From: Dan Grove <dan@grove.cx>
Sent: Wednesday, October 5, 2022 10:25 PM
To: Molly McGuire
Subject: Comment Letter for Proposed Redevelopment of 6950 SE Maker Street, Permit 2207-019
Attachments: Dan's Letter for Submission (4).pdf

Comment Letter for Proposed Redevelopment of 6950 SE Maker Street, Permit 2207-019

Figure 2A: Locations of the contour slices in Figure 2B

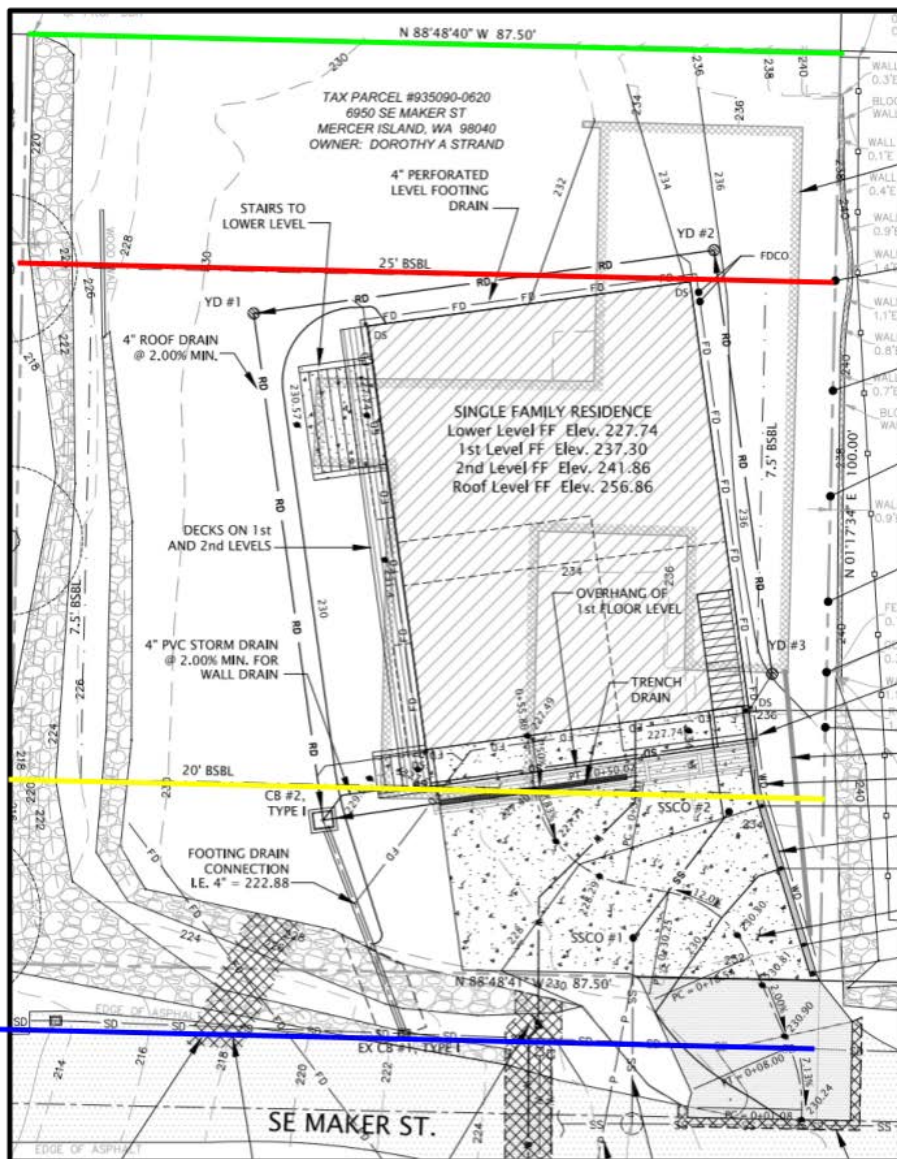
Third, an analysis of cross sections taken through and around The Project shows the degree of artificial elevation. Figure 2A shows 4 east-west cross sections through The Project whose elevation we can measure based on either the known Existing Grade at the lot's boundaries or based on data from The Project's proposal. The colors of each line match the colors in Figure 2B, which shows the elevation as one travels along each line, east to west.

Figure 2B: Current Elevations from East Property Boundary to West Boundary

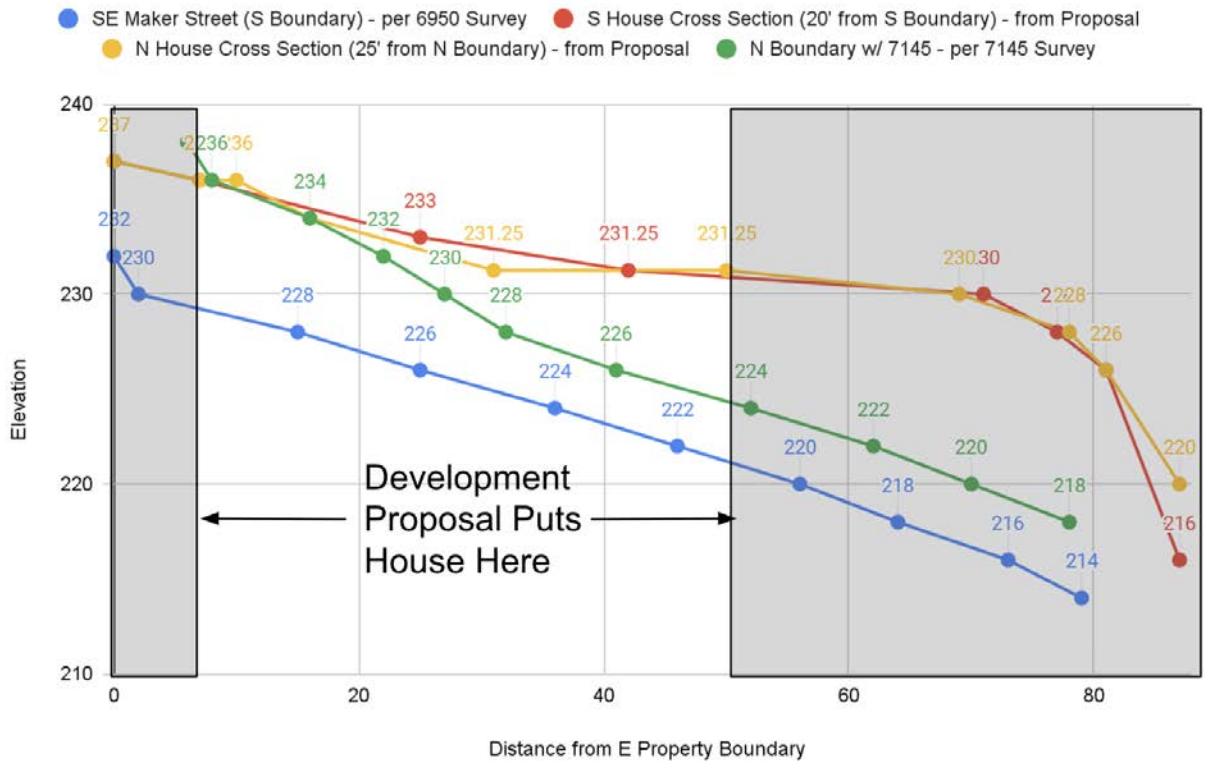
Figure 2B shows that the cross sections corresponding to The Project’s building location (in yellow and red) have been significantly artificially elevated (by as much as 10’). The photo in Figure 1 matches the lines in blue (showing the SE Maker Existing Grade) and yellow (showing the proposed Existing Grade on an east-west line 20’ from SE Maker) in Figure 2B at 42’ from the E property boundary. Please see Dr. Elisabeth Green’s comments on the elevation data from a professional geologist’s perspective (submitted independently).

Figure 3: Image from Survey of 7145 SE 35th. 6950 Basement is on the left, North is to the right. Note that the contours go all the way to the house walls of 6950.

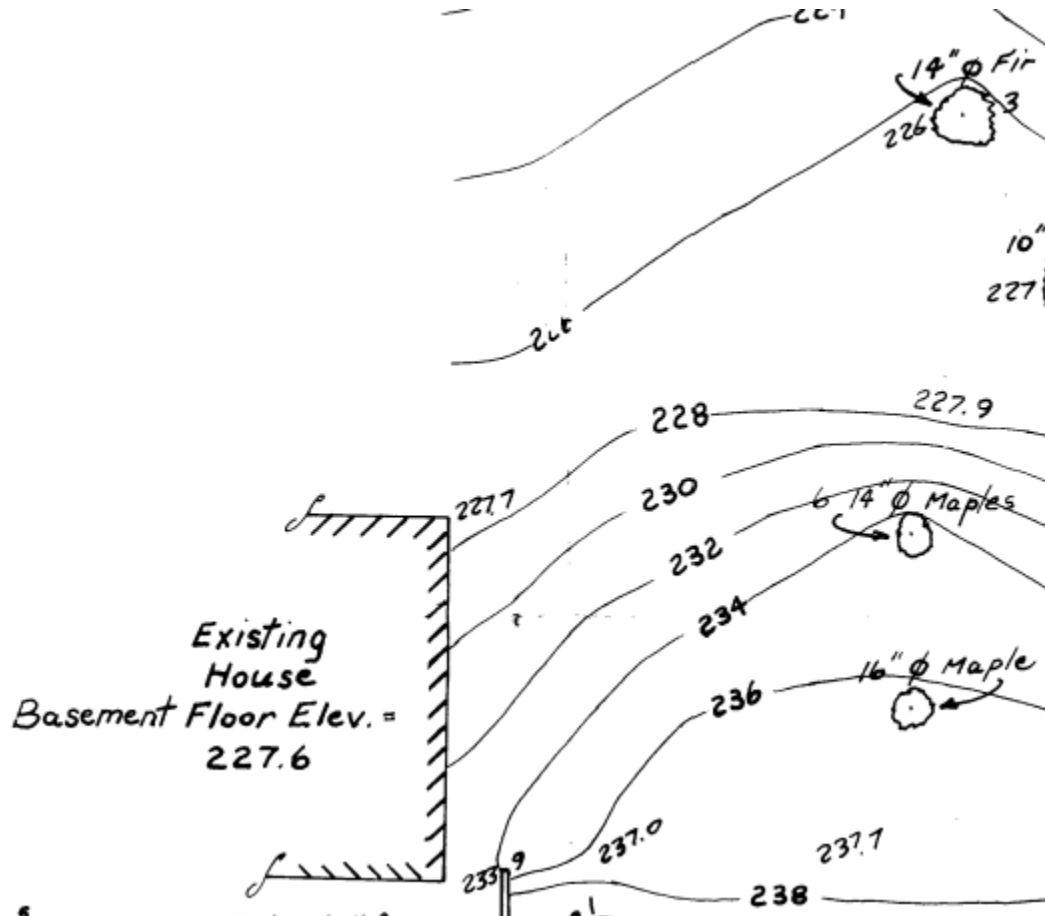
1. **The pre-development survey of 7145 SE 35th Street (the “7145 Survey”)** provides detailed and compelling evidence of the original lot conditions immediately north of the 6950 house. This survey includes the basement of 6950, and the Existing Grade immediately adjacent to the present 6950 house. The survey shows several large trees across the 7145 property, and close to the site of the current 6950 house. These mature trees help to date the topography of 7145 to earlier than the development of 6950 (the photo in Appendix B offers further proof), and offer contour lines for establishing approximate topographic elevations. In addition, the [7145 SE 35th Geotech Study](#) (also carried out in 1989) provides specific insights into three boreholes north of 6950 (see the bottom of page 3 of the geotech study). These boreholes show a natural forest floor with no fill underneath. **In conclusion: triangulating these data points helps establish the correct “approximate topographic elevations” of the north side of 6950.**

2. **The Project's own survey** enables further triangulation of the 7145 Survey data. The 6950 basement's Finished Floor ("FF") is represented in both surveys and provides a common point of reference. The [Project's survey](#) from 2022 (page 2) represents the elevation of 6950 basement's FF at **228.7'**. The 7145 Survey from 1989 lists the FF at **227.6'** (as shown in Figure 3. The fairly small difference in the two elevations can be attributed to changed techniques for measuring elevation in the intervening years). **In conclusion: using the 6950 basement as a common reference point makes it possible to establish the original contours on the north side of 6950 relative to the basement.**

Figure 4 - Interpolating Approximate Topographic Elevations of the Project based on the 7145 Survey for the Northern Boundary and the current 6950 survey for SE Maker Street. Details on how Jim Mattison and I created this can be found in Appendix C.

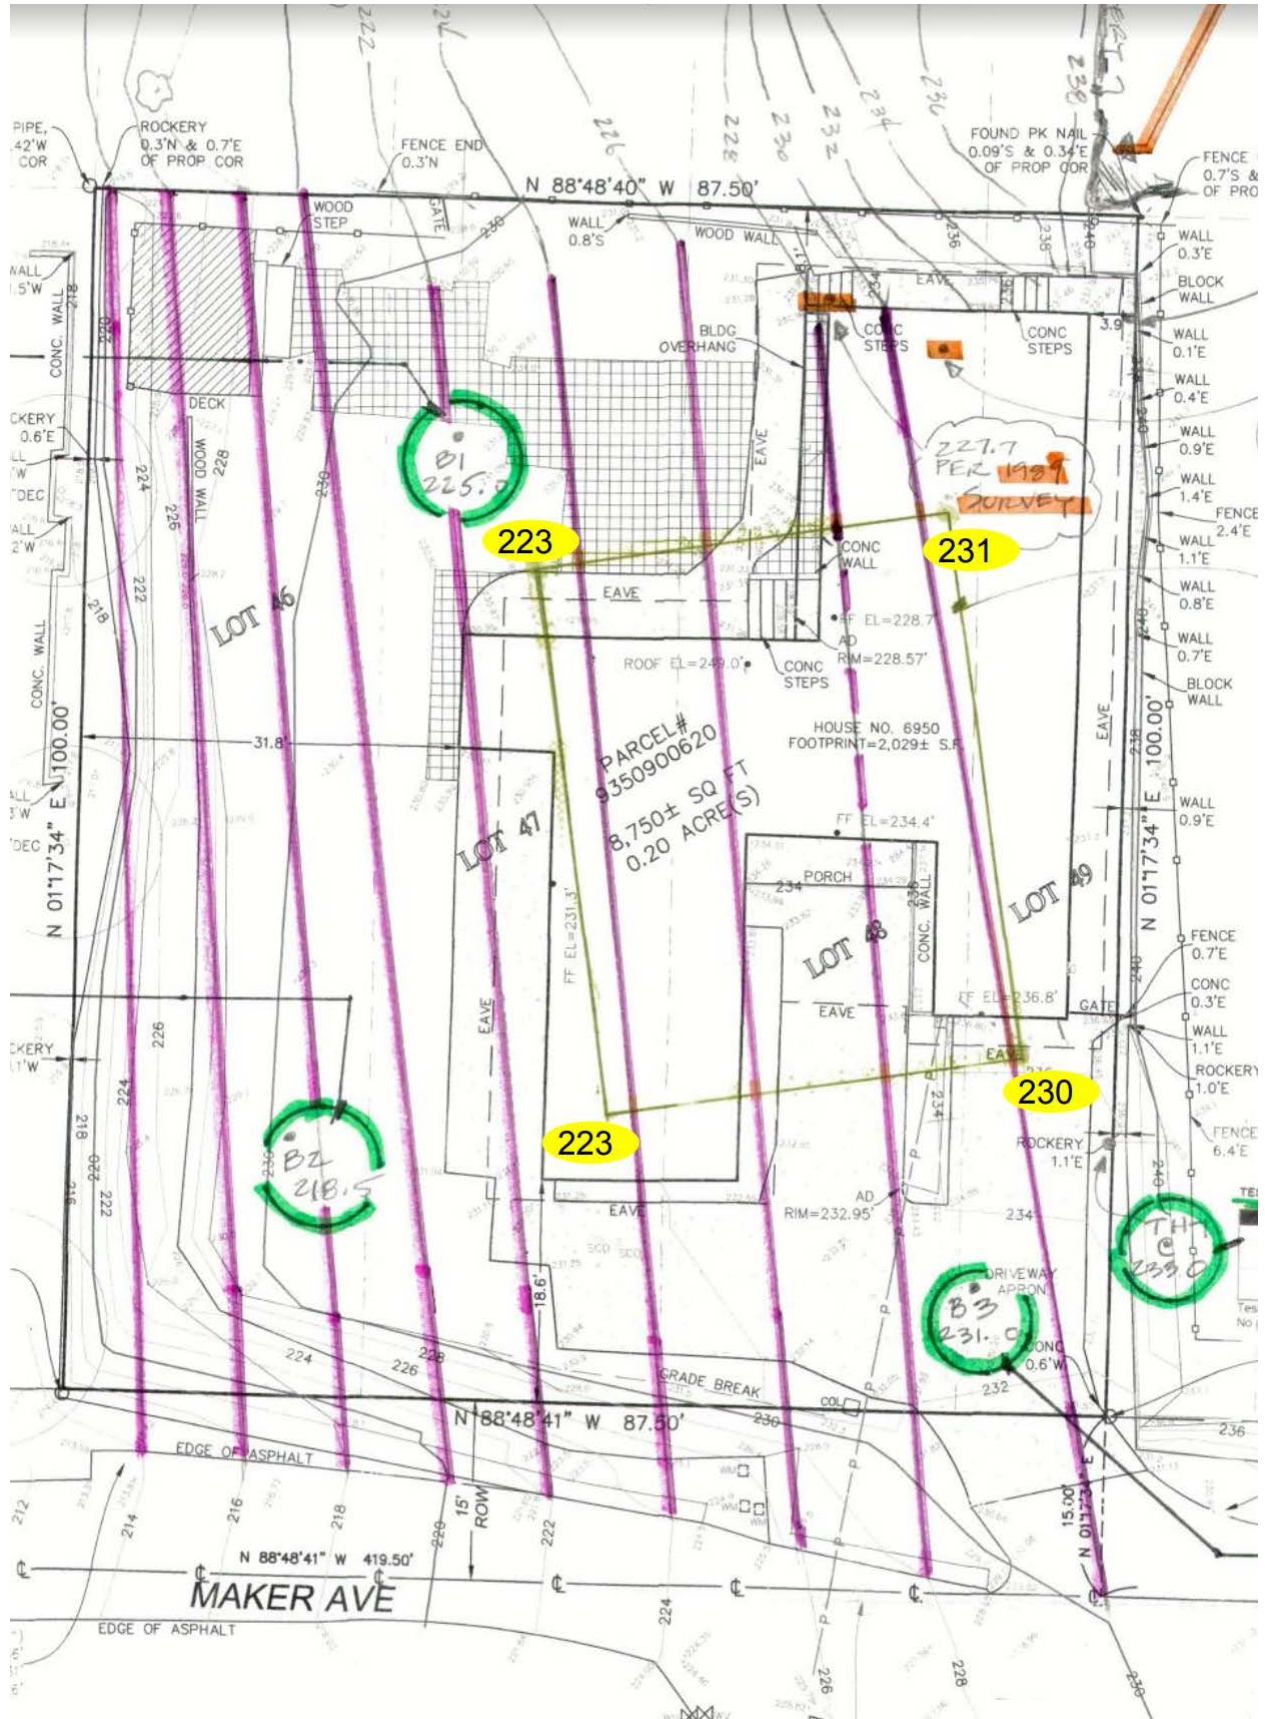
In Figure 4 above, The Project's outline is shown in yellow, and interpolated elevations are shown in yellow ovals at each corner.

The interpolated grades make sense in the context of the lot's surroundings. It is clear to the eye that the slope around The Project drops primarily from East to West, and secondarily from North to South. We would expect to see contours dropping in elevation as one moves from NE to SW, which is exactly the scenario in these interpolated contours.

Figure 5: Interpolating Approximate Topographic Elevations of The Project based on the 1961 Survey

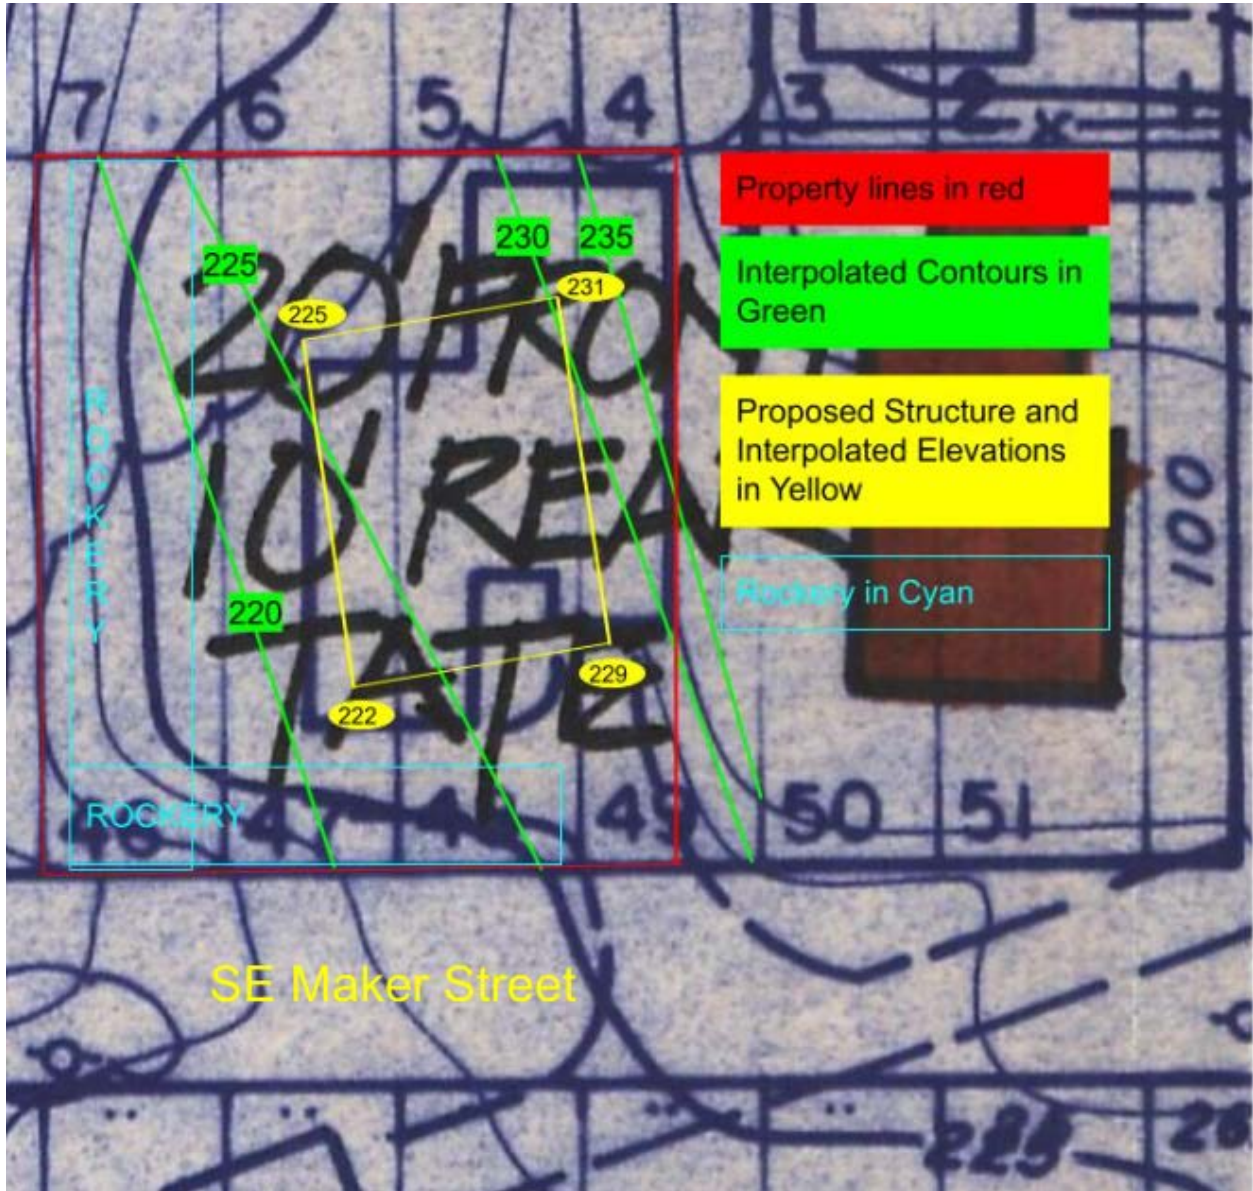
In order to try to verify this set of findings, I interpolated contours from the edges of the 6950 property onto the 1961 Survey, as shown in Figure 5 (these contours are at 5' intervals because that was the resolution of the 1961 Survey). I then placed The Project over these interpolated contours. The result is shown below, including The Project and the Existing Elevations of its corners in yellow.

A comparison of The Project's building corners when overlaid onto these two interpolated contours (from the 7145 Survey and the 1961 Survey) shows remarkable consistency. In turn, this consistency attests to the alignment of these two surveys—independently conducted, decades apart, by different parties—and thus underscores the reliability of both surveys.

Corner of The Project	7145 Survey	1961 Survey	Difference between surveys for this corner
NW	223'	225'	-2.0'
NE	231'	231'	0.0'
SE	230'	229'	+1.0'
SW	223'	222	+1.0'

Figure 7: Photographic evidence that the gravel road shown in the 1961 survey was present prior to development of 6950.

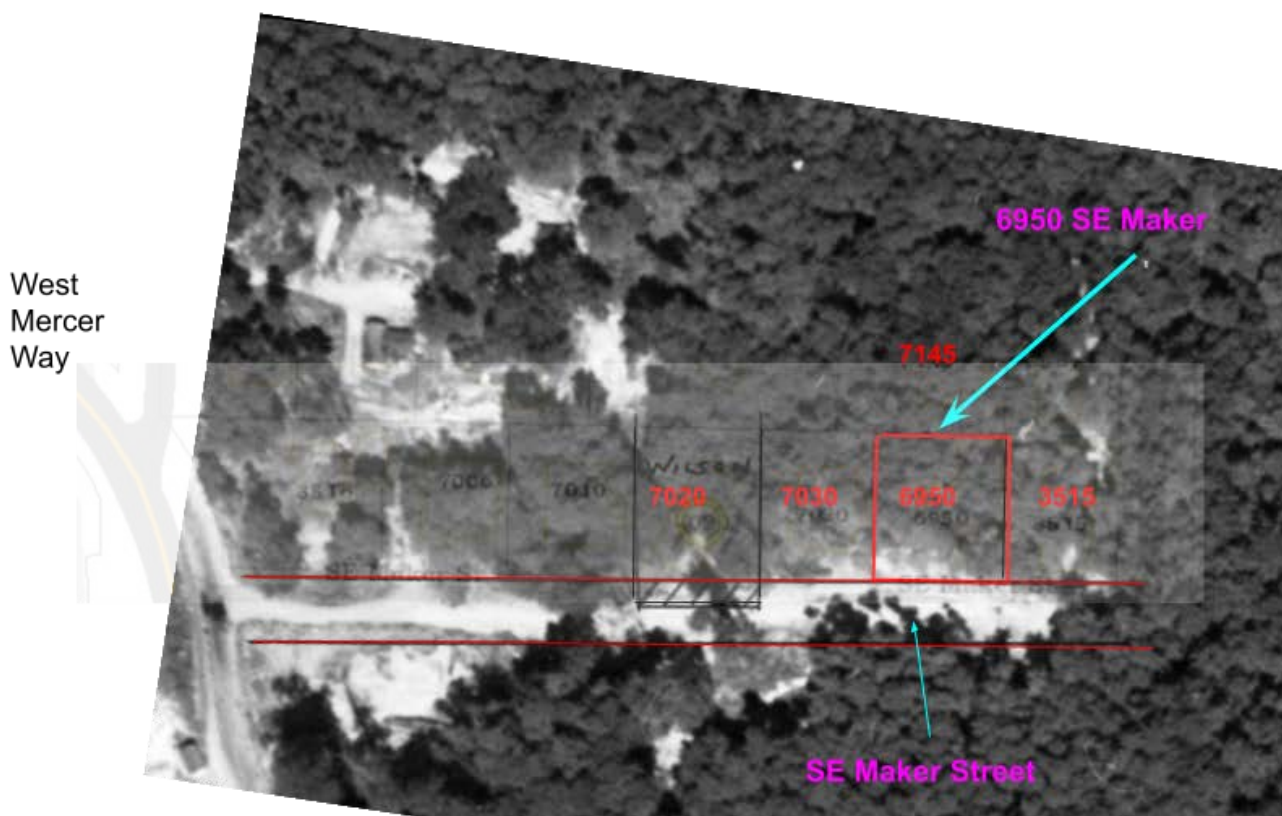
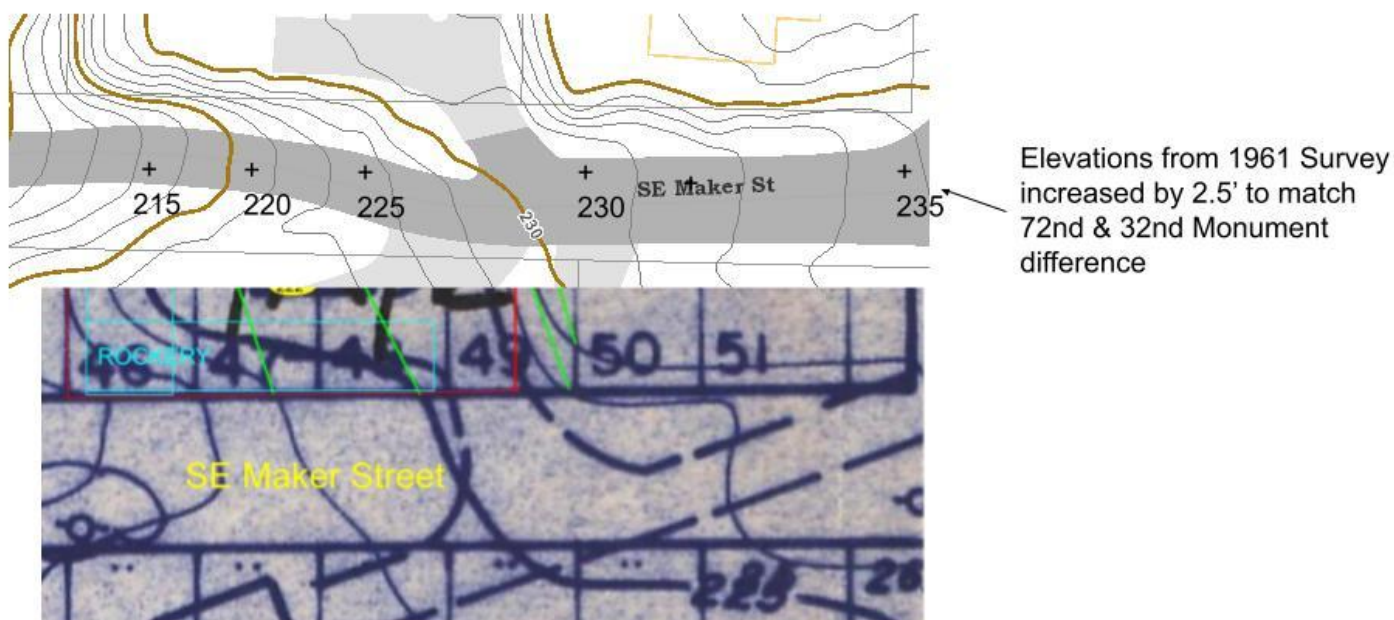
- The gravel SE Maker Street shown in the 1961 survey was present prior to development of 6950.
- The photo shows the original condition of the lot of 6950, which differs drastically from its condition today.

- SE Maker Street was a gravel road that was first paved no earlier than 1963, according to Mercer Island Public Works. Figure 7 shows this road.
